APPLICATION NO.	FILING DATE	FIRST NAMED INVENTOR	ATTORNEY DOCKET NO.	CONFIRMATION NO.
18/322,293	05/23/2023	Yusuke YAMAMOTO	8323-0058	4056

Office Action Summary	Application No. 18/322,293	Applicant(s) YAMAMOTO, Yusuke	
	Examiner DZUNG T TRAN	Art Unit 2893	AIA (First Inventor to File) Status Yes

DETAILED ACTION

Fig. 9 (Seki '119)

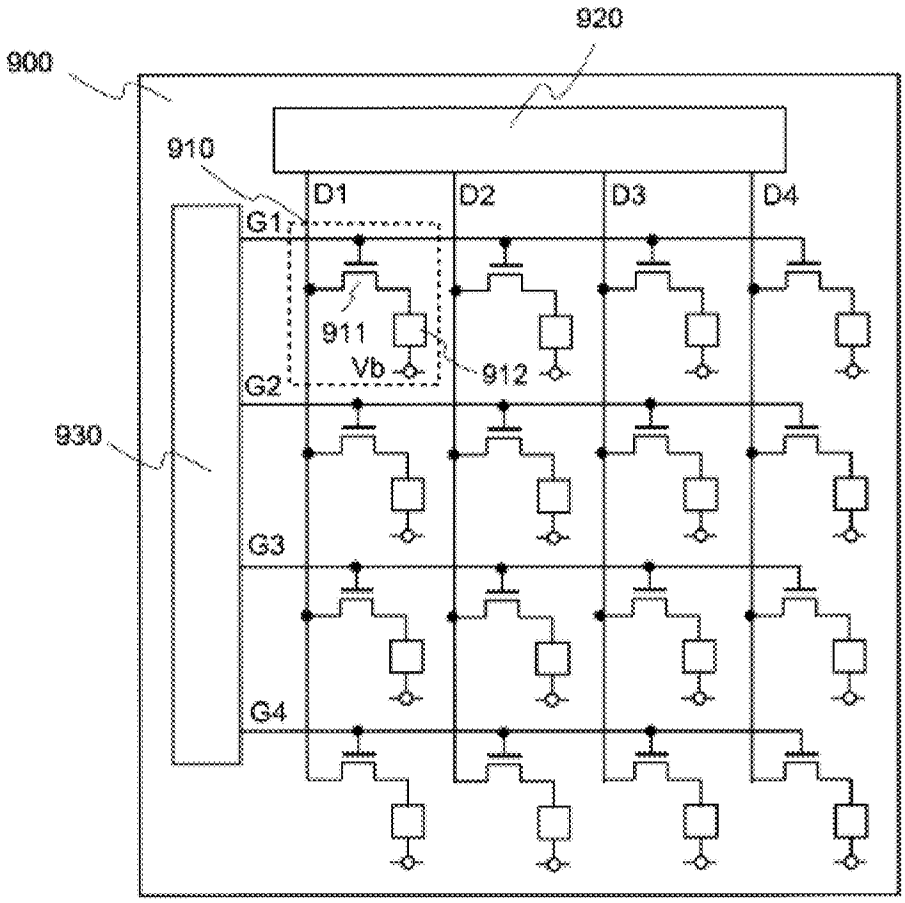
pixels arrayed (Fig. 9, (910); [0078]) on a substrate (200; [0063]); and

a data line (D1-D4; [0078]) that transmits a signal read from each of the pixels, wherein the pixel includes: a photodetector (912; [0078]); and an N-type switch thin film transistor (911;

[0078]) between the photodetector (912) and the data line (D1-D4), wherein the switch thin film transistor includes: an oxide semiconductor part (130; [0047]); a gate electrode (110; [0047]); a drain electrode (140; [0047]) towards the data line; and a source electrode (145; [0047]) towards the photodetector (see Fig. 1).

Regarding Claim 6, Seki '119 teaches the switch thin film transistor (911) is connected between a cathode terminal of the photodetector (912) and the data line (D1) (see Fig. 9).
